Southwest Agincourt Transportation Connections Study **Phase 2 Consultation Report**

August 10, 2022

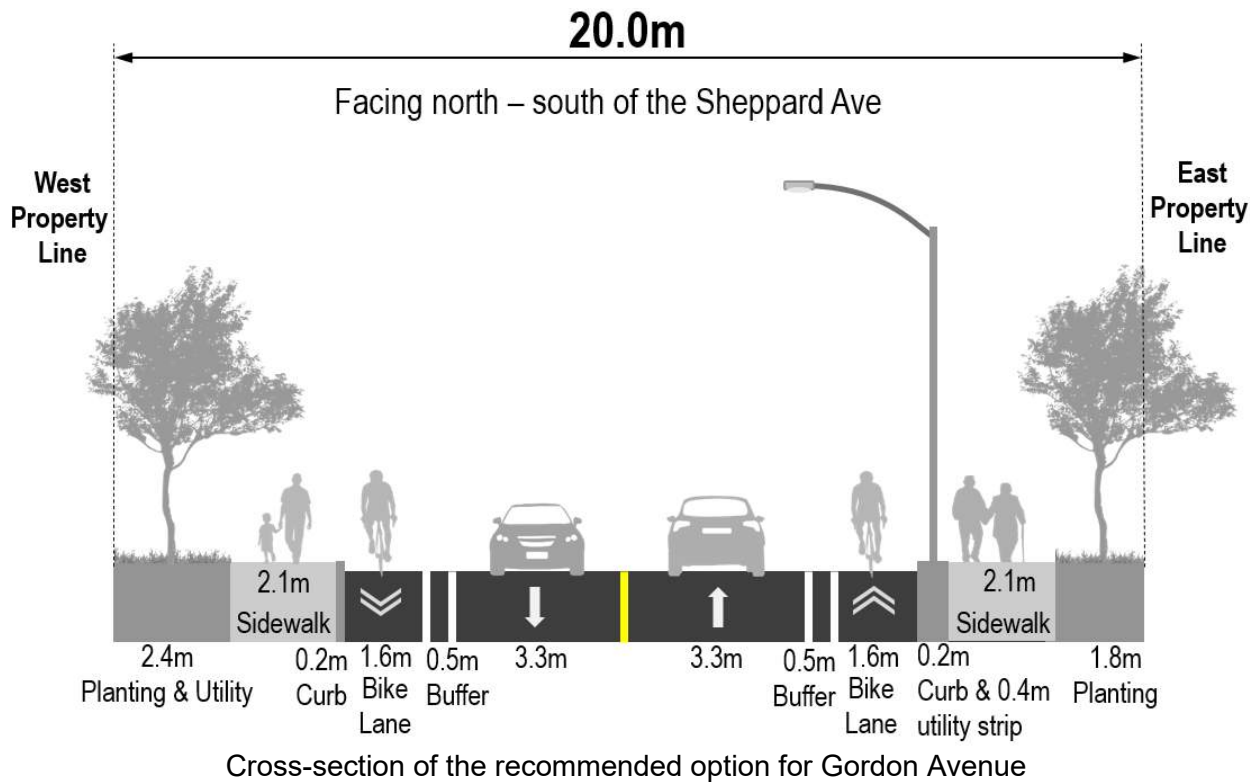
Topic	Comment Summary
Access to Village Green Square	<ul style="list-style-type: none">• The new complete street provides an alternate access route to and from Village Green Square for residents and emergency vehicles, which currently only has one access route• Residents would be able to access Sheppard directly without going through Kennedy Road
Connection to green spaces	<ul style="list-style-type: none">• The alignment directly connects the green spaces in the area
Reduce congestion	<ul style="list-style-type: none">• The new street would reduce traffic congestion in the area, especially on Kennedy Road
Safe route for pedestrians, cyclists and transit	<ul style="list-style-type: none">• The new complete street makes it safer for pedestrians and cyclists• The realignment of Cowdray Court to create a perpendicular intersection makes it safer• It preserves the potential for public transit

Topic	Comment Summary
Additional traffic signal	<ul style="list-style-type: none">• The additional traffic signal at Gordon Avenue and Sheppard Avenue East would worsen congestion• The spacing between the traffic signals is too tight• There are already long queues in left turn lanes along Sheppard
Congestion	<ul style="list-style-type: none">• The route would become an unintended shortcut for vehicles, increasing vehicular traffic on Gordon Avenue• Traffic would be busy with only one lane each direction
Connection to destinations	<ul style="list-style-type: none">• The alignment is not direct enough to connect to Agincourt GO Station• The new street is not close enough to Collingwood Park
Cost	<ul style="list-style-type: none">• The project would cost taxpayers money
Left turns	<ul style="list-style-type: none">• The new configuration would make it difficult to turn left from Sheppard Avenue East onto Gordon Avenue and Reidmount Avenue

Noise and air pollution	<ul style="list-style-type: none">• The new street would generate noise and air pollution from the additional traffic in this quiet neighbourhood• Construction would create noise and dust
Out of scope	<ul style="list-style-type: none">• A better alternative would be to create a connection between Village Green Square and Midland Avenue
Parking	<ul style="list-style-type: none">• Lack of street parking on Gordon Avenue would affect the plaza, doctor's office and the church
Safety	<ul style="list-style-type: none">• The increase in traffic would make it less safe for children and seniors living in this neighbourhood
Winter maintenance	<ul style="list-style-type: none">• Fast snow removal is needed at the underpass as there might be black ice at that location

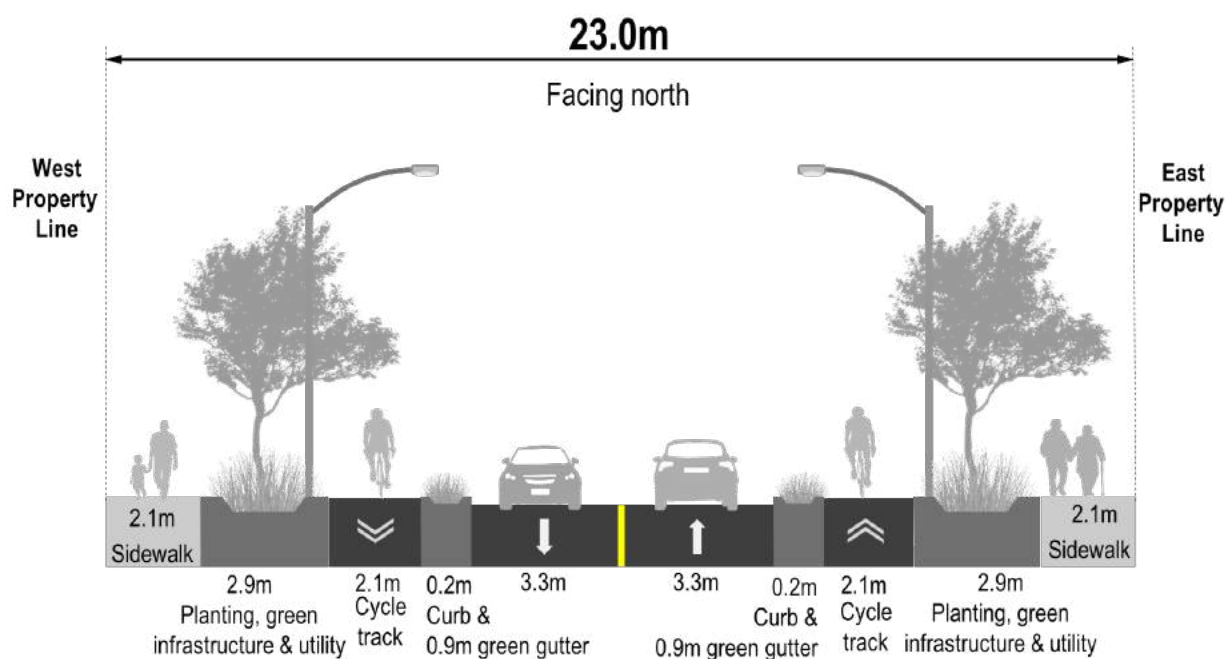
Topic	Comment Summary
Convenience for commuters	<ul style="list-style-type: none"> Sidewalks make it more convenient for commuters travelling to Agincourt GO Station
Cycling infrastructure	<ul style="list-style-type: none"> Bike lanes provide safety for cyclists
Wide sidewalks	<ul style="list-style-type: none"> Wider sidewalks improve pedestrian safety and accessibility

Topic	Comment Summary
Physical separation	<ul style="list-style-type: none"> There should be physical separation such as flexible posts or curb to protect cyclists Cars will pull into the painted bike lanes
Low traffic	<ul style="list-style-type: none"> The low volume of pedestrian and vehicular traffic on Gordon Ave is not worth the cost to go forward with this project There would be limited bike traffic

Cross-section of the recommended option for the new section of the complete street

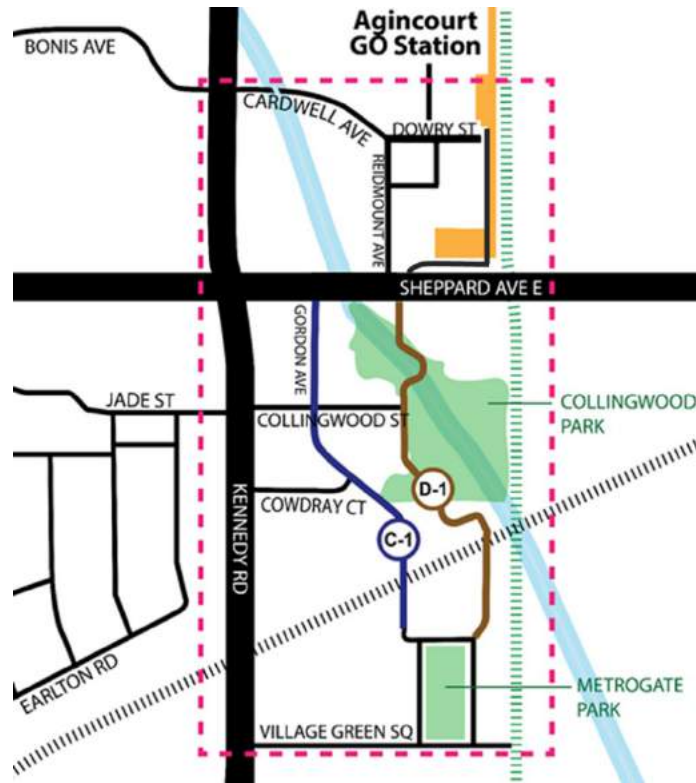
Topic	Comment Summary
Greenery	<ul style="list-style-type: none"> There is a good amount of greenery and green infrastructure, which makes the area more beautiful
Physical separation	<ul style="list-style-type: none"> The cycle track buffer makes it much safer and more comfortable for cyclists of all ages and abilities Wider bike lanes are better The City should consider protected intersections, raised crosswalks and pedestrian/cyclist signal detection
Wide sidewalks	<ul style="list-style-type: none"> Wider sidewalks improve pedestrian safety and accessibility

Topic	Comment Summary
Cyclist safety	<ul style="list-style-type: none"> There is no way for cyclists to enter or leave the bike lanes other than at intersections, where vehicular lanes are too wide 1.8 m wide buffered bike lane is good enough
Increased traffic	<ul style="list-style-type: none"> There would be more pedestrian and vehicular traffic in the area, which would be disruptive to residents
Parking	<ul style="list-style-type: none"> Parking on Collingwood Street would be challenging when others park there
Traffic signal at Cowdray Ct	<ul style="list-style-type: none"> Traffic signal at Cowdray Court is not necessary, a stop sign is sufficient
Winter maintenance	<ul style="list-style-type: none"> The recommended option with the road and cycle tracks would make it difficult for snow removal

Map of the recommended multi-use trail alignment (D-1), shown with the recommended complete street alignment (C-1)

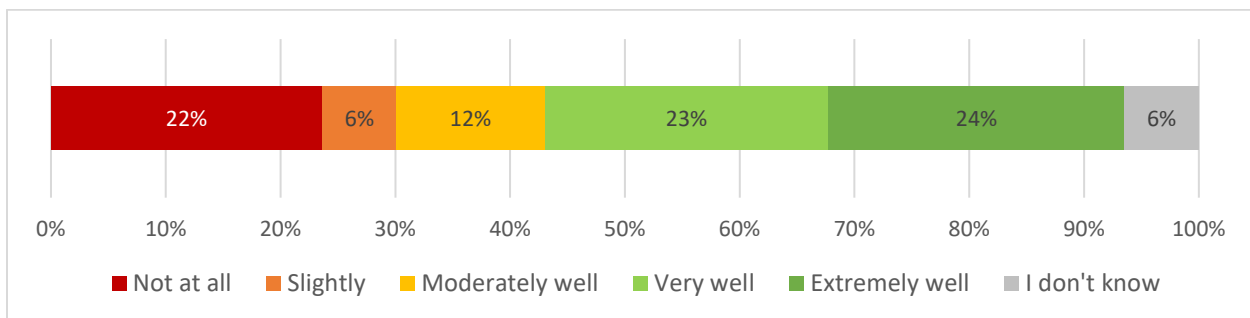
Topic	Comment Summary
Access to Collingwood Park	<ul style="list-style-type: none"> The trail provides a new option for pedestrians and cyclists to directly access Collingwood Park The trail would enhance the park, which is now underused due to limited access

Topic	Comment Summary
	<ul style="list-style-type: none"> The trail connects communities at Metrogate and Agincourt Drive/Lockie/Huntingwood to Collingwood Park
Congestion relief	<ul style="list-style-type: none"> It would help with traffic considering the additional condo development in the neighbourhood
Connection to GO Station	<ul style="list-style-type: none"> The multi-use trail directly connects Village Green Square to Agincourt GO Station, which would reduce congestion and carbon emissions Residents no longer have to detour to Kennedy to access the GO Station
Promotes walking and cycling	<ul style="list-style-type: none"> The trail would promote the use of bicycles The trail is nice to have for pedestrians and cyclists Residents would have a longer trail for walking and cycling
Safety	<ul style="list-style-type: none"> A multi-use trail separate from cars is a safer option for pedestrians and cyclists The trail provides a safe pathway for families and children

Topic	Comment Summary
Development	<ul style="list-style-type: none"> The recommended alignment would substantially impact the development potential of certain properties
Impact to wildlife	<ul style="list-style-type: none"> The park is home to many animals and plants
Overcrowding of Collingwood Park	<ul style="list-style-type: none"> Collingwood Park would become more crowded, leading to more litter and noise Many children and seniors currently use the park
Proximity to new complete street	<ul style="list-style-type: none"> Since C-1 and D-1 are parallel and very close to each other, and the complete street would include bike lanes, so D-1 would not be necessary If the City could create a trail here, then there should also be a road along this route to eliminate the traffic impact of an additional light
Safety	<ul style="list-style-type: none"> Residents are concerned about the existing encampment in the area There are concerns about safety of the trail especially at night because of its relatively remote location and if it is not well lit Users of the trail would feel safer if C-1 and D-1 share the same access points The lack of winter maintenance is a safety concern There would be potential conflict between cyclists and children playing at the park

Width and location	<ul style="list-style-type: none"> The trail is too narrow for both pedestrians and cyclists The access point should be on a less busy side The trail should include safe connections to areas outside of the study area

Stylized plan view of Sheppard Avenue East with the recommended interim cycle track

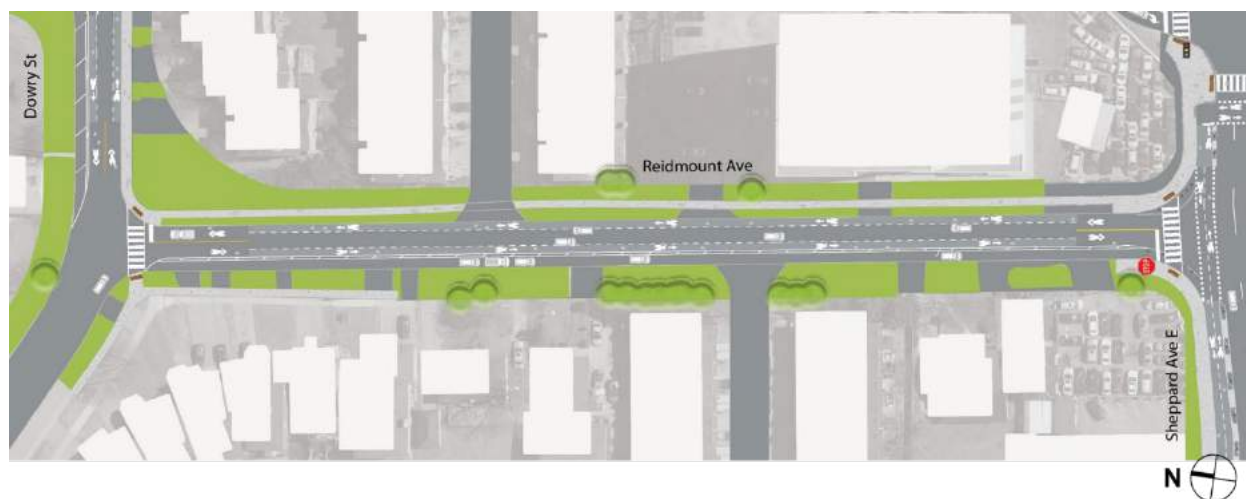
Topic	Comment Summary
Connection of cycling facilities	<ul style="list-style-type: none"> The design is sensible for a connection between Gordon Avenue, the multi-use trail and Agincourt GO
Environment	<ul style="list-style-type: none"> It promotes cycling, which is more environmentally friendly

Topic	Comment Summary
Safety	<ul style="list-style-type: none"> It improves safety for cyclists travelling on Sheppard

Topic	Comment Summary
Congestion	<ul style="list-style-type: none"> The cycle track would worsen congestion when Sheppard is already very busy There are other cycling options on Bonis, Cardwell and Reidmount
Cycle tracks on both sides	<ul style="list-style-type: none"> The cycle tracks should be on both sides of Sheppard because it would make it easier to expand in the future
Extension of cycle track	<ul style="list-style-type: none"> The cycle track should continue west to Agincourt Mall and beyond Cyclists would have to share the road or ride on the sidewalk when the cycle track ends
Lack of cyclists	<ul style="list-style-type: none"> There is not much bike traffic in the area A study of how many cyclists would use this cycle track should be done
Construction	<ul style="list-style-type: none"> It would lead to more pollution and noise in the area
Safety	<ul style="list-style-type: none"> The intersection at Reidmount should be changed to sharp corners, allowing the crossing to be next to the bike lane and discouraging drivers from stopping on the crossing and bike lane Sheppard is a very busy road that is not safe for cyclists, especially for children Since the cycle track is temporary, it may confuse cyclists in the long term There is not enough buffer or protection for cyclists There should be buffers on both sides of the cycle track and speed limits should be enforced or lowered It could be dangerous if both cyclists passing in opposite direction collide and fall into traffic
